AMENDMENT OF SOLICITATION/MODIFICATION OF CONTRACT				1. CONTRACT ID CODE J	PAGE OF PAGES 1 7
2. AMENDMENT/MODIFICATION NO. 0002		3. EFFECTIVE DATE 10-Feb-2010	4. REQUISITION/PURCHASE REQ. NO.		5. PROJECT NO.(If applicable)

14. DESCRIPTION OF AMENDMENT/MODIFICATION (Organized by UCF section headings, including solicitation/contract subject matter where feasible.) The purpose of this amendment is as follows: 1. Attached is the revised Section 00010 Bid Schedule and Section 01010 Scope of Work, and attached annotated General Site Plan Drawings. 2. THE OFFEROR DUE DATE IS CHANGED TO 17 FEBRUARY 2010 - 5:00PM.					
Except as provided herein, all terms and conditions of the document referenced in Item 9A or 10A, as heretofore changed, remains unchanged and in full force and effect.					
15A. NAME AND TITLE OF SIGNER (Type or print)			16A. NAME AND TITLE OF CONTRACTING OFFICER (Type or print)		
			TEL: _____ EMAIL: _____		
15B. CONTRACTOR/OFFEROR _____ (Signature of person authorized to sign)	15C. DATE SIGNED	16B. UNITED STATES OF AMERICA BY _____ (Signature of Contracting Officer)		16C. DATE SIGNED 09-Feb-2010

BID SCHEDULE**CAMP THUNDER SECURITY UPGRADES, GARDEZ, AFGHANISTAN**

General Site Plan

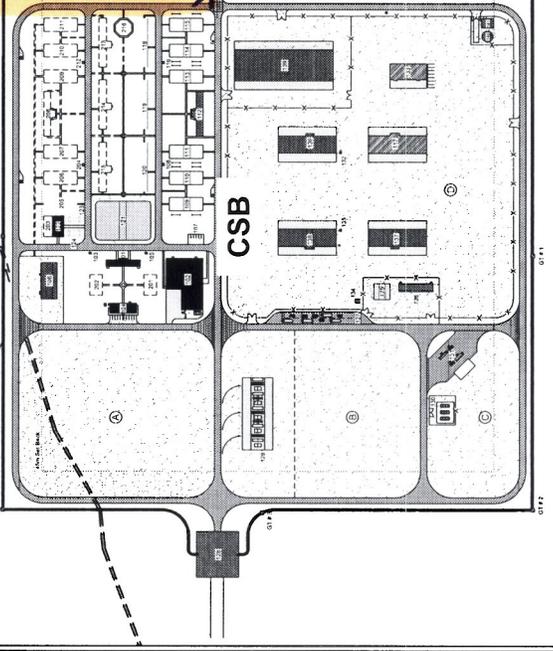
(700 LM REMOVED FROM SCOPE)

- 700 LM HESCO DEMO REMOVED
- 700 LM FENCE DEMO REMOVED
- 700 LM ALL WALL CONSTRUCTION REMOVED

General Site Plan (Continued)

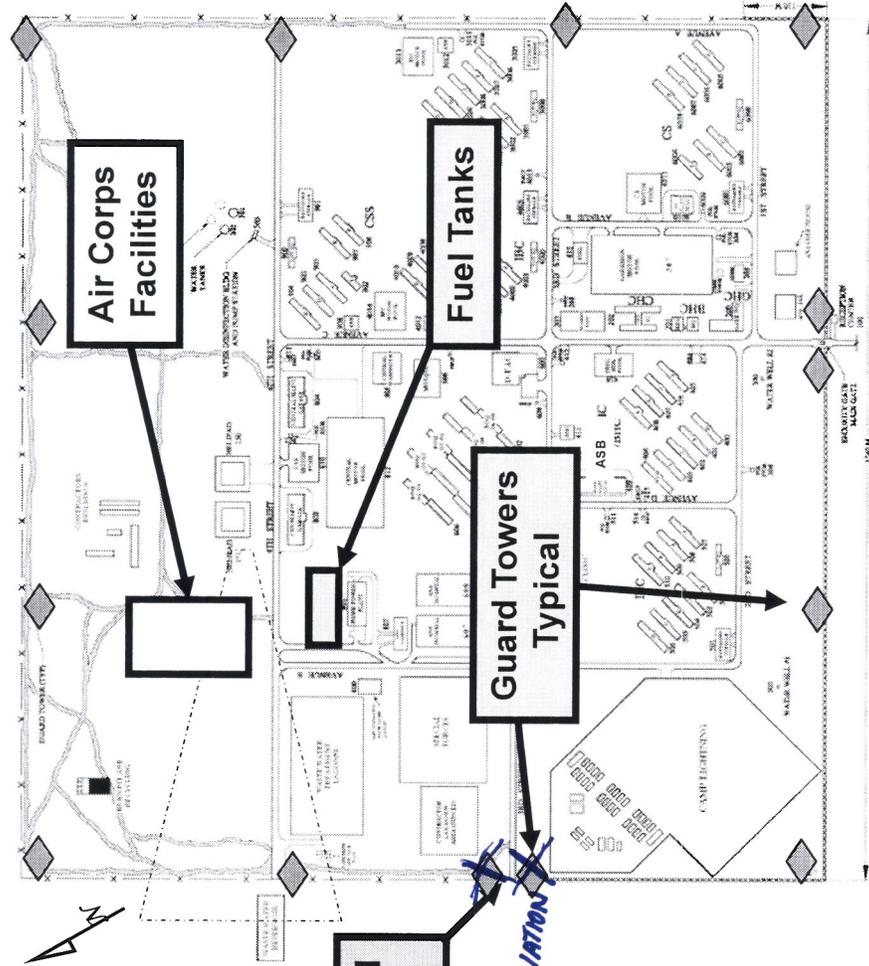
REMOVE 2 GUARD TOWER RENOVATION FROM SCOPE AS SHOWN.
